# Service Bulletin

Bulletin No.: 17-NA-302

**Subject: Dust, Snow or Water Around Fuel Filler Area**

4869504

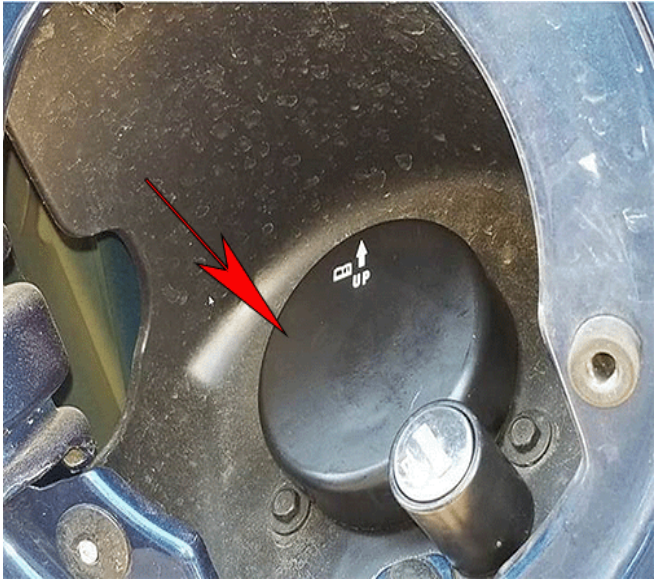
<b>Involved Region or Country</b>	North America, Middle East, Israel, Chile and Thailand.
<b>Condition</b>	Some customers may comment on excess amount dirt, snow or water that can build up around the fuel filler neck.
<b>Cause</b>	This condition may be caused when trucks are operated in high amount of dirt, dust or snow which can migrate to the filler cap area.
<b>Correction</b>	<p><b>Locking Gas Cap</b></p>

<p style="margin: 0;"><b>Non - Locking Gas Cap</b></p> <div style="text-align: center; margin: 10px 0;">  </div> <p style="text-align: right; margin: 0; font-size: small;">5458913</p> <p style="margin: 10px 0;">Notify the customer that GM has made available a gas cap for drivers that operate in these environments. This will help to protect the fill area and the fuel system.</p>
--	--
